SYDNEY SOUTH PLANNING PANEL

SSPP No:	2017SSH005
DA No:	DA16/1810
Local Government Area:	Sutherland Shire
Proposed Development:	Stage 3 of construction of an aged care facility being the erection of a 5 storey building containing 33 self contained seniors housing units and amendment to Stage 1 Masterplan Development Consent DA08/0808
Street Address:	Lot 1 DP 1097917 19 Kiama Street (also known as 86-110 Bellingara Road), Miranda
Applicant/Owner:	HammondCare
Number of Submissions:	Three
Regional Development Criteria (Schedule 4A of the Act)	General Development over \$20 million
List of All Relevant s79C(1)(a) Matters	<ul style="list-style-type: none"> State Environmental Planning Policy (Housing for Seniors or People with a Disability) 2004 (Senior's SEPP) State Environmental Planning Policy No. 55 - Remediation of Land State Environmental Planning Policy No. 65 – Design Quality of Residential Flat Development (SEPP65) State Environmental Planning Policy (Infrastructure) 2007 (ISEPP) State Environmental Planning Policy (Building Sustainability Index: BASIX 2004) (BASIX) Greater Metropolitan Regional Environmental Plan No. 2 – Georges River Catchment (REP2) Sutherland Shire Local Env

Images C and D: views from objector's balcony (front and rear respectively) towards the Captain Cook Bridge and the land/water interface around Rocky Point

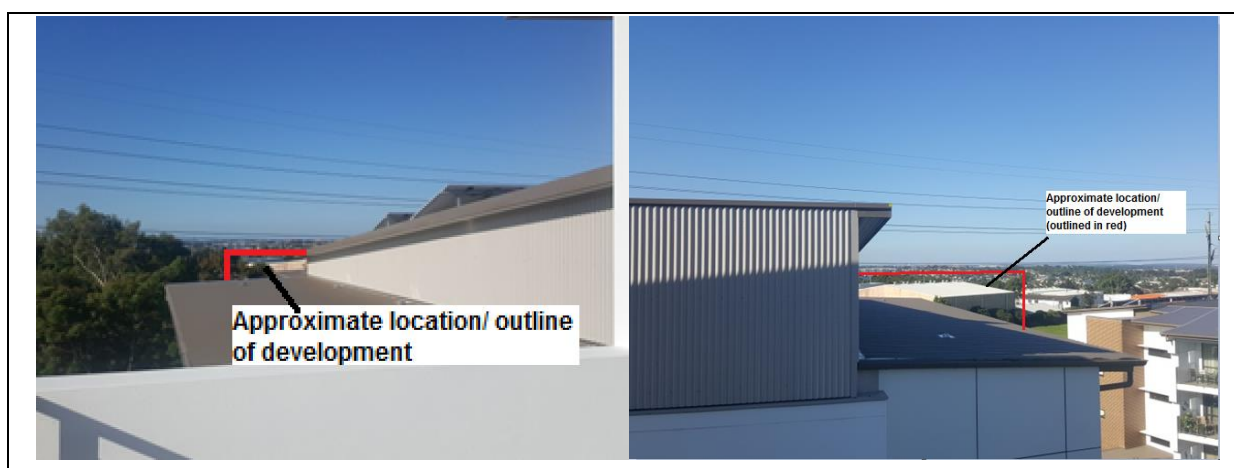
Views from the objector's apartment (Unit 503, Stage 2) are of the Captain Cook Bridge, the land/water interface around Rocky Point and planes arriving and leaving the airport (refer to Images C and D below). The views of the bridge and the point are distant (approximately 2.7km) and partially obscured by mature vegetation and power lines.

Views are only obtained from the side of both front and rear balconies and only from a standing position. Views are obtained looking over the site's side property boundary and over a significant number of properties, aided by the height of the fifth level apartment. Views are not available from any internal spaces. The unit has a view plane of 123° and of that view plane, views towards the bridge and the point account for only 42°, or 34%.

Views from the rear balcony are likely to be lost completely whereas views from the front balcony will be partially lost by the proposed development. The Masterplan approved 5, 4 to 6 storey unit blocks located between the Stage 2 development and the northern property boundary and as such, some

Further, the proposed development has a roof height of RL35.0 while the floor level of the objector's unit has a level of RL33.5, a 1.5m difference. From a standing position, it is likely that views towards the bridge and land/water interface will be retained from the front balcony, albeit with some impact.

Based on the Tenacity principals, the view impact is considered minor.
